# UNITED STATES PATENT AND TRADEMARK OFFICE

APPLICATION NO.	FILING DATE	FIRST NAMED INVENTOR	ATTORNEY DOCKET NO.	CONFIRMATION NO.
09/993,054	11/06/2001	Merrit N. Jacobs	CDS-255	9036

# Office Action Summary

## **DETAILED ACTION**

**FIG. 5**

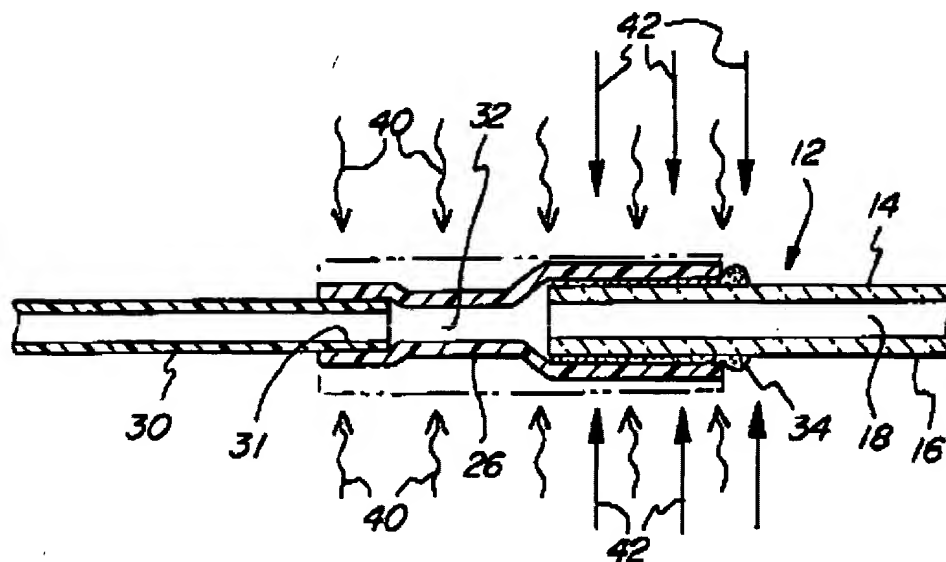
As to claim 20, the examiner directs applicant's attention to Figure 5 (given herein). It is clearly shown in the figure plastic coupling 26, may be manufactured to any desired shape/diameter to couple together various sizes of conduits. The element 26 is very similar to applicants Figure 8. It is clearly seen in the figure that element 26 does comprise transition zones of unequal diameters at each end for the insertion of different sized conduits.

Greenfield discloses a connecting tube device 32 that meets all the limitations of the claim. The tube as seen in Figure 5, comprises 3 cavities formed by a wall, a middle cavity that transitions outward into two adjacent cavities.

Greenfield discloses a connecting tube device 26,32 that meets all the limitations of the claim. The tube as seen in Figure 5, comprises 3 cavities formed by a wall, a middle cavity that transitions outward into two adjacent cavities.

Greenfield does not specifically recite the plastic tube 26 forms an end cavity with a diameter at least equal to three times the value of the smaller diameter. .

While Figure 5 appears to show tube 26 as meeting the limitation, it would have been obvious to one of ordinary skill in the art at the time of the invention to recognize that the plastic tube 26, 32 may also be formed or heat shrunk to accommodate or allow for the coupling of various sizes of conduits.

Greenfield discloses a connecting tube device 26, 32 that meets all the limitations of the claim. The tube as seen in Figure 5, comprises 3 cavities formed by a wall, a middle cavity that transitions outward into two adjacent cavities.
